Non-Conformance Report - 1

Date Submitted: Wednesday, June 01, 2016
Job Name/No.: Waitsfield / #23480
Piece Mark #'s: MD-SP2 (7)
Production Date: 5/31/2016
QA Inspector, Co.: M. Holmes, HRV

DECK PANEL - MD-SP1(7)
AS-BUILT.
1/2" = 1'-0"

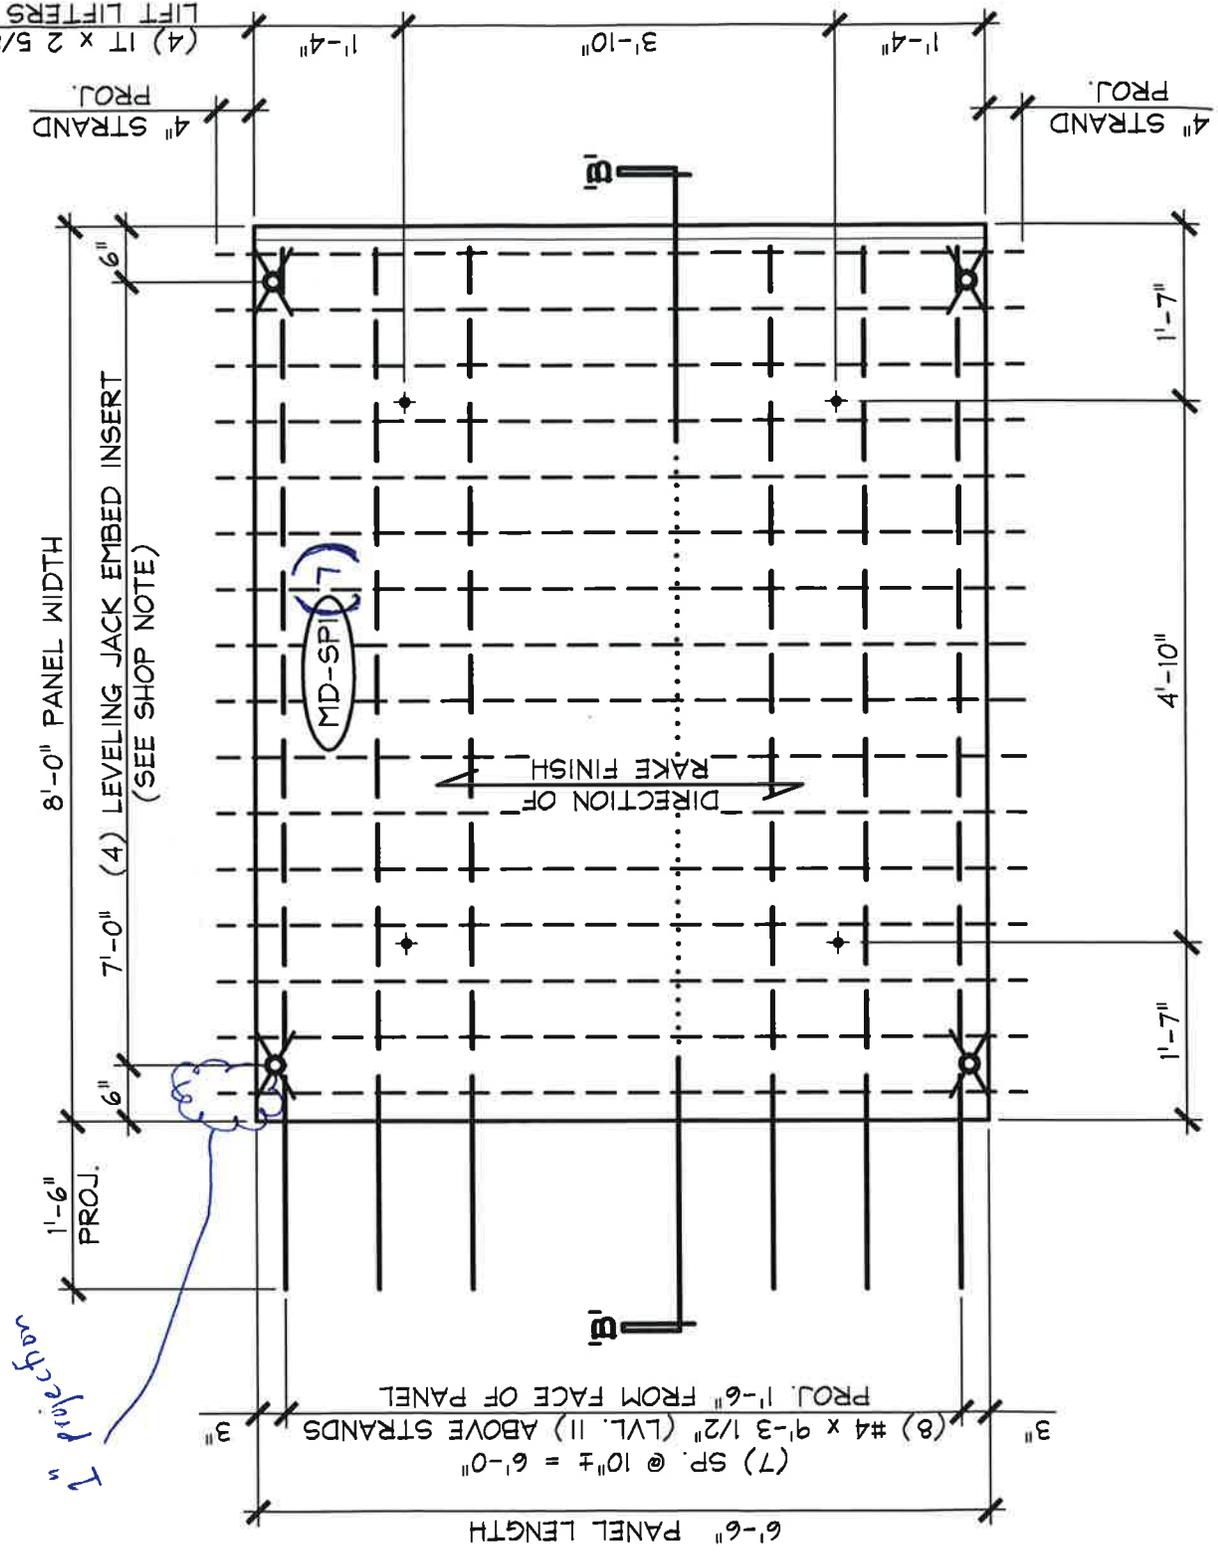
➡ One of the strands on panel SP2(7) was mistakenly cut short of the desired 4" projection during detensioning - see attached photo and detail.

- ▶ A bolt at the edge of the form that holds the header in place posed a conflict for personnel attempting to cut the strand at the midpoint between the headers. Personnel have been informed that the bolt can be removed prior to detensioning to allow for better access to cut the strand in the correct location.
- ▶ JPC proposes that the panel be accepted as is.
